**CERTIFICATE OF APPROPRIATENESS**

**Property:** 424 Euclid Street, Lot 6, Block 12, Woodland Heights Subdivision. The property includes a historic 1,623 square foot, one-story wood frame single-family residence, detached rear shed, and a detached rear garage situated on a 5,000 square foot (50’ x 100’) interior lot.

**Proposal:** Alteration – Addition

**Recommendation:** Denial - does not satisfy criteria

**NORTH ELEVATION – FRONT FACING EUCLID STREET**

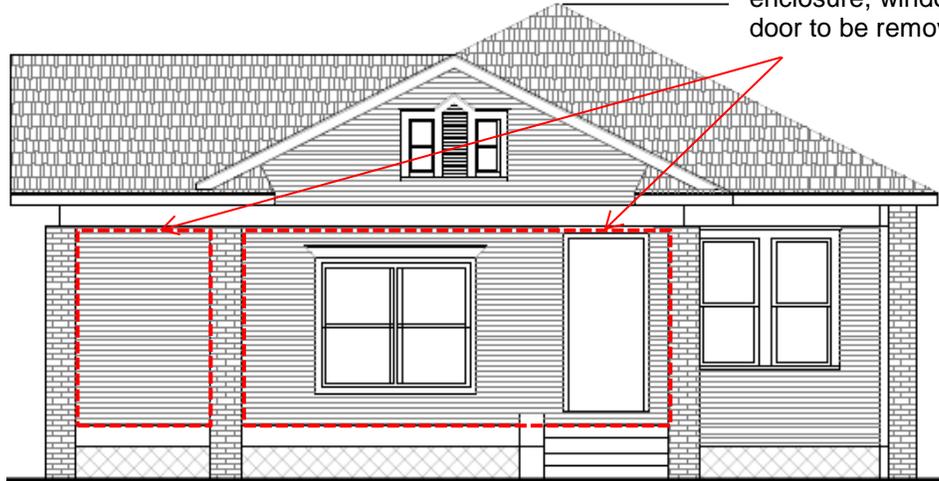
Non-original front porch enclosure, windows, and door to be removed

**EAST SIDE ELEVATION**

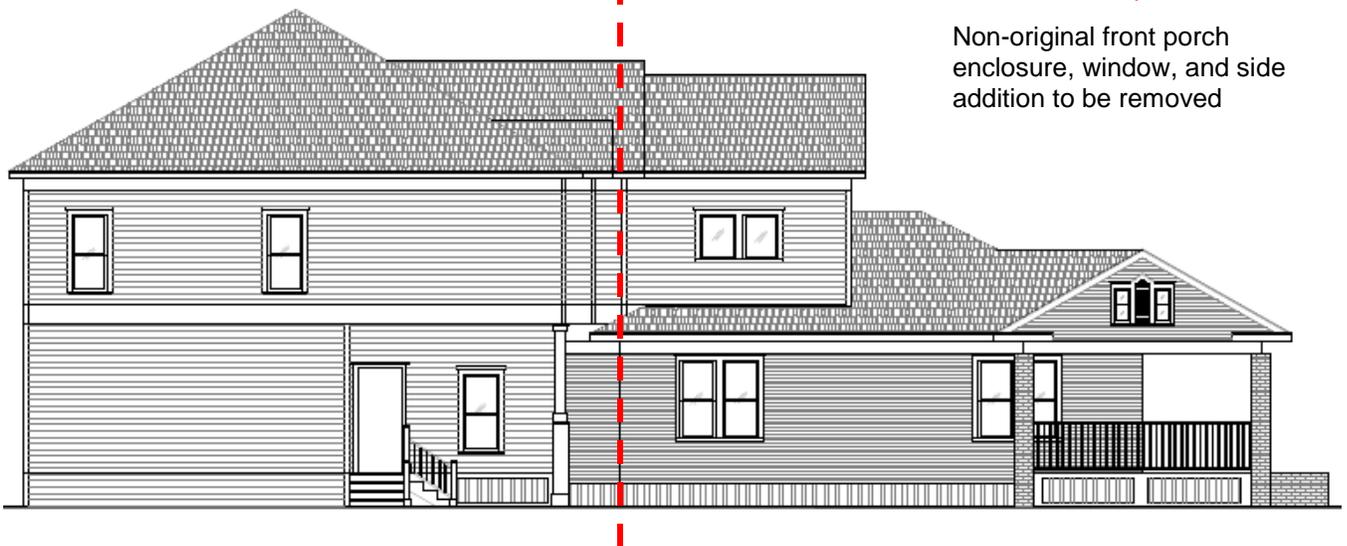
Non-original front porch enclosure, window, and side addition to be removed

**ROOF PLAN  
EXISTING**

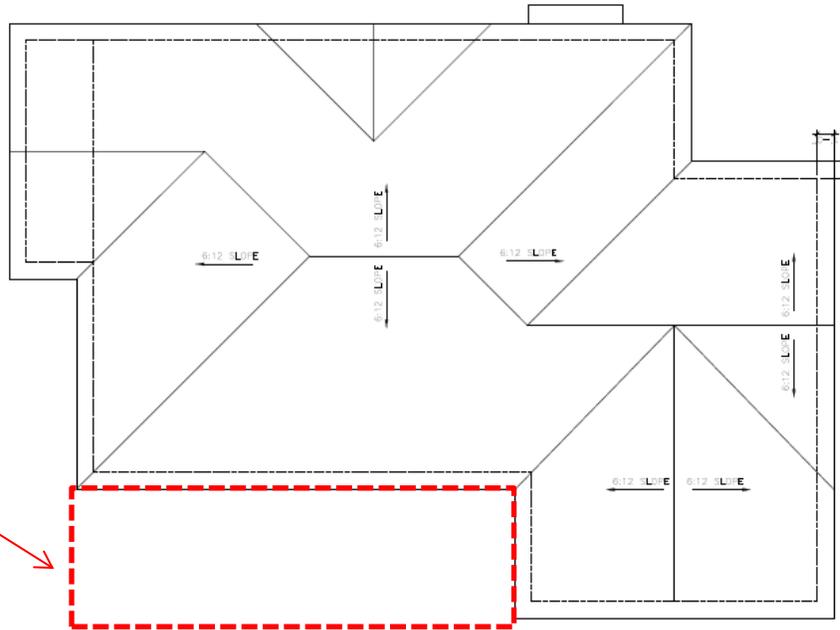
Non-original side addition  
to be removed

**EXISTING NON-ORIGINAL EAST SIDE ADDITION**

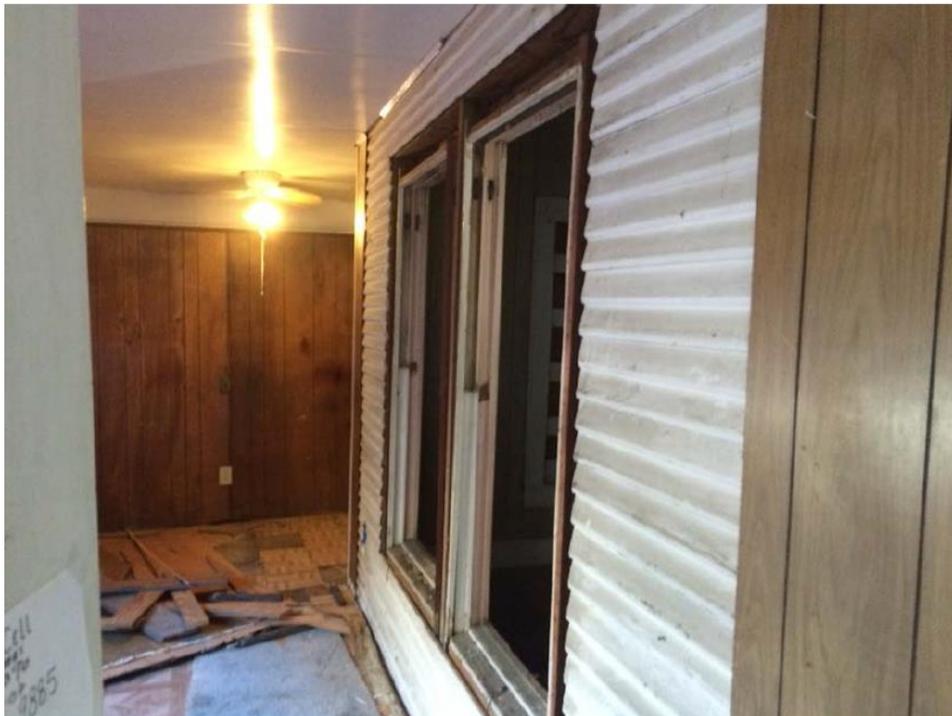
**Side Elevation:** A non-original side addition and porch enclosure will be removed. The cladding and window openings behind the non-original addition will be retained. The addition will encroach upon the
